Asset Recovery Information

Alvey 880 Palletizer
Serial Number #01-KH15
Asset # CP000153
Location: Ross Products Division, Columbus Plant
Contact: Kelly Niekamp 614-624-6213

Manufacturer Audit

Audit Report # I4923 Ross Products Division /Abbott Laboratories

5 Infeed Belt Assembly

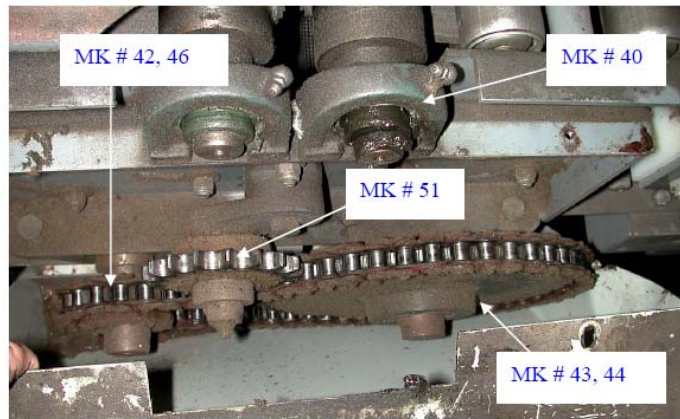
- 1) The motor drive chain is rusted, in very bad condition, and needs to be replaced.
- 2) The drive sprocket is still okay, but the driven sprocket has worn teeth.
- 3) Lots of cleaning is needed in the infeed area.
- 4) Chains must be kept lubricated.

a. Drive

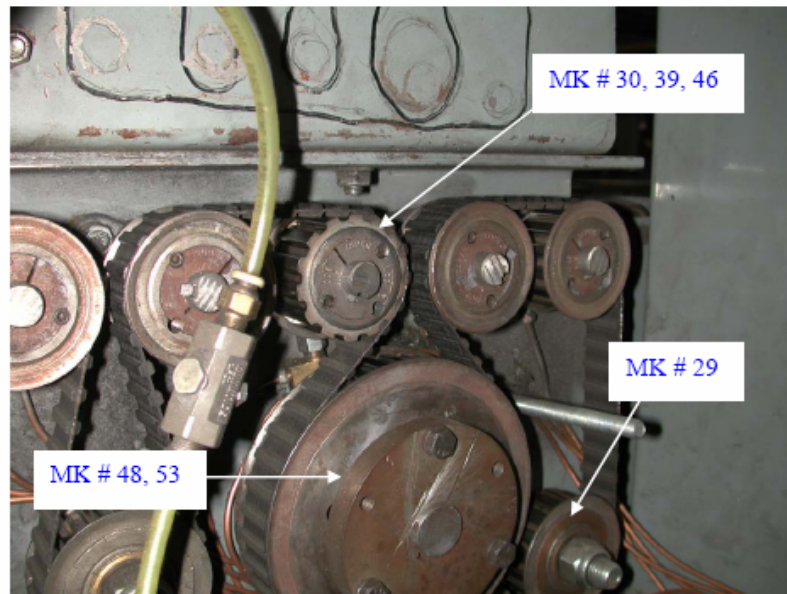
- 2) The belt is too loose. It needs to be tightened up. There is some belt misalignment.

- 3) The large cog gear has a bent flange. Replacement would be the best option.
- 4) The lower left and right gear idlers have worn bearings. They need to be changed.
The lower right side idler is missing its flange.
- 5) The third from last gear idler (top row) is missing the flange.

b. Rollers

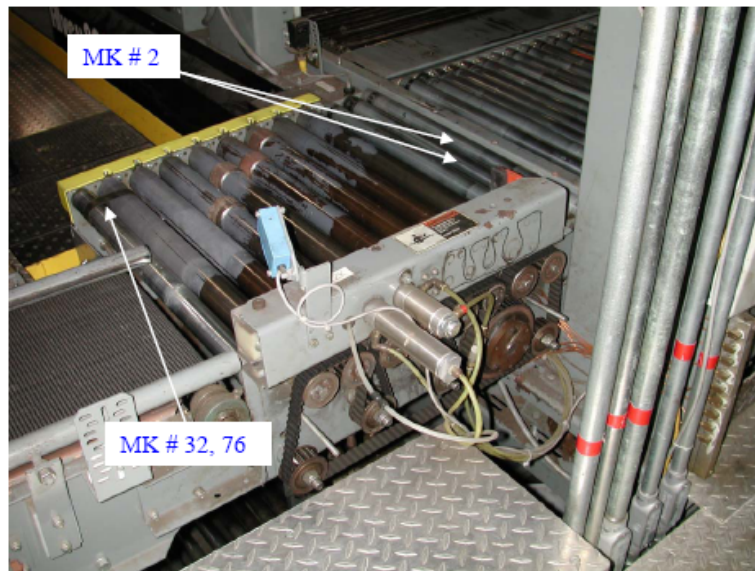
- 1) The first roller is powered by slaving it off the powered rollers. The use of a tracking band, and activator band is required. The tracking band is missing, and the activator band is worn. Both need to be replaced.
- 2) The second from last roller has quite a bit of bearing wear. It is now marginal.
- 3) The third from last roller has an excessively worn bearing. It will need to be changed right away.

7 Bump Turner

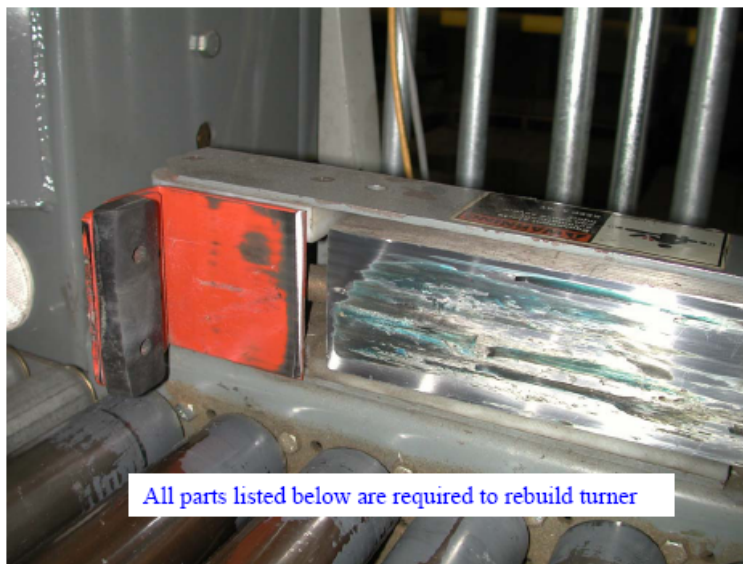
- a. The air cylinder mounting bracket is loose and needs to be tightened down.
- b. There is a rather severe air leak. It seems that the air cylinder seals might be leaking.
- c. The bump turner wear parts are now marginal and should be considered for replacement.
- d. The bumper pad is worn

9 Case Stops

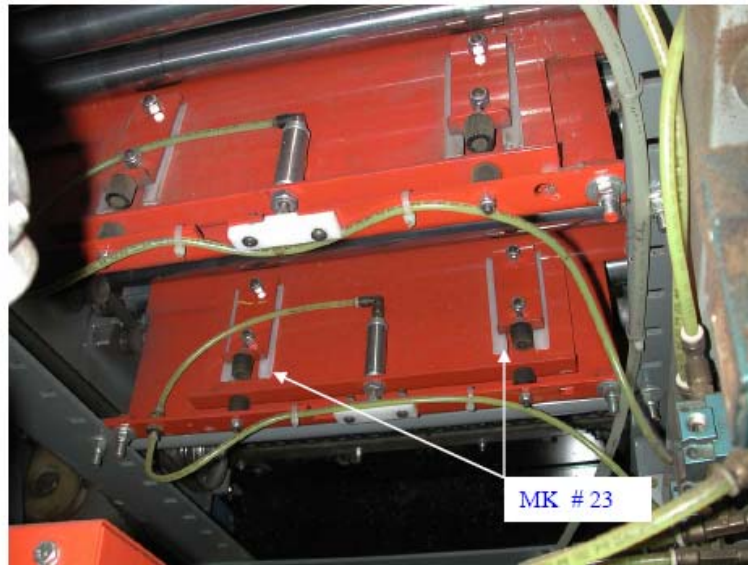
- a. New wearstrips are needed on the case stops. The blades are too loose. It is best if the stop blades do not contact the rollers. In the interim of replacing the wearstrips, tightening the mounting bolts may help.

10 Pusher Bar**a. Guarding**

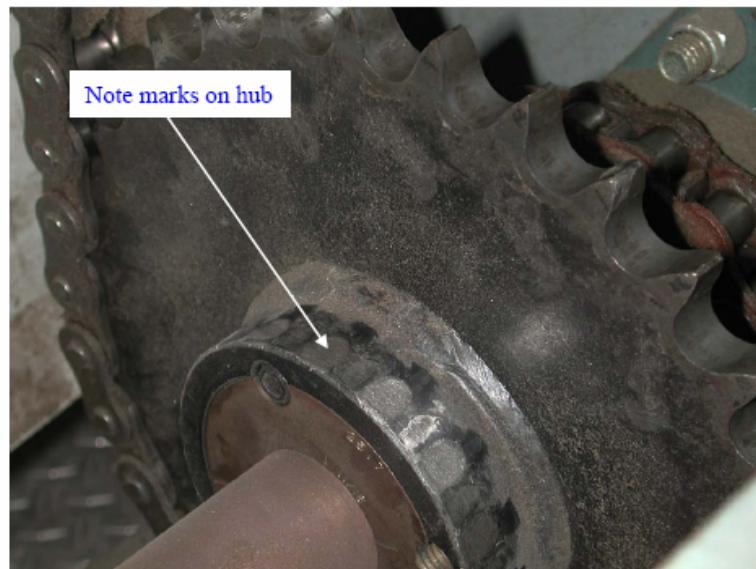
- 1) The guarding is not in the proper position. It will need to be put back on correctly before running the machine.

e. Pusher Bars

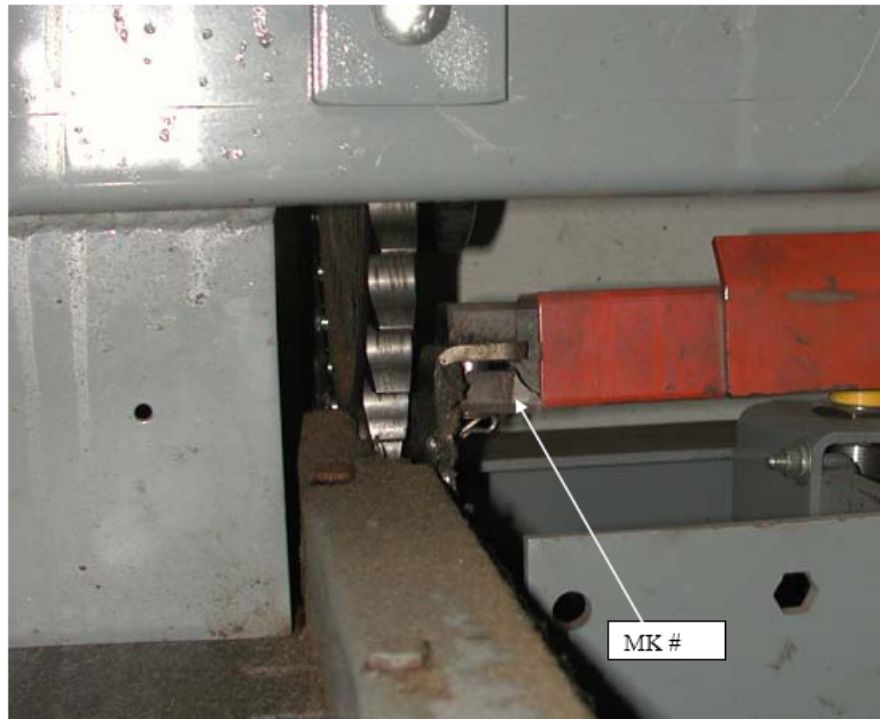
- 1) One of the right side end connection blocks is broken. It needs to be changed immediately

12 Hoist

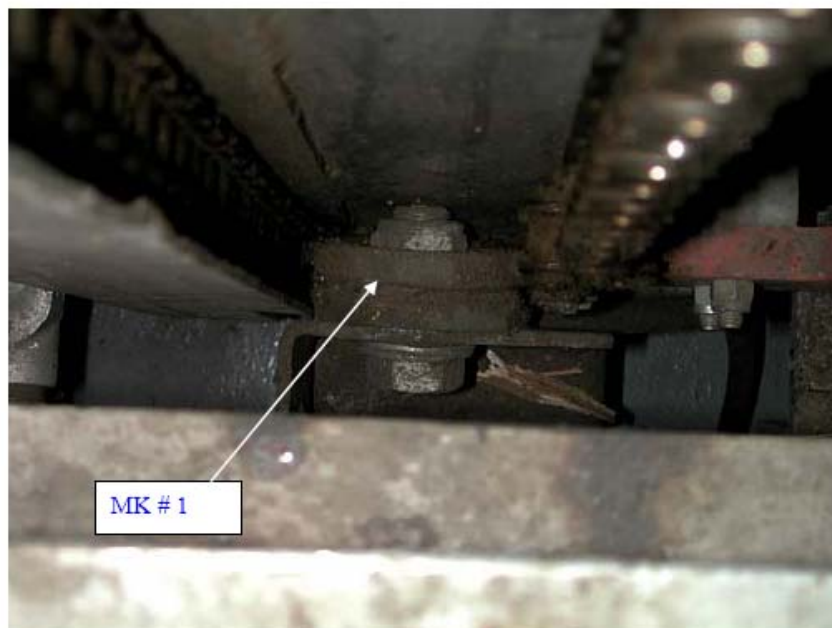
- b. The table is out-of-level. For best operation, it should be leveled.
- c. The lower right side hoist chain idler has a bent bracket and is worn. The bracket must be fixed and a new idler installed.
- d. The transition rollers between the hoist table and the full load discharge section are sitting crooked. It seems that the frame is bent. This is probably not a major problem but it will, of course, push the load to one side while exiting the machine. It can be easily fixed if it becomes a problem.
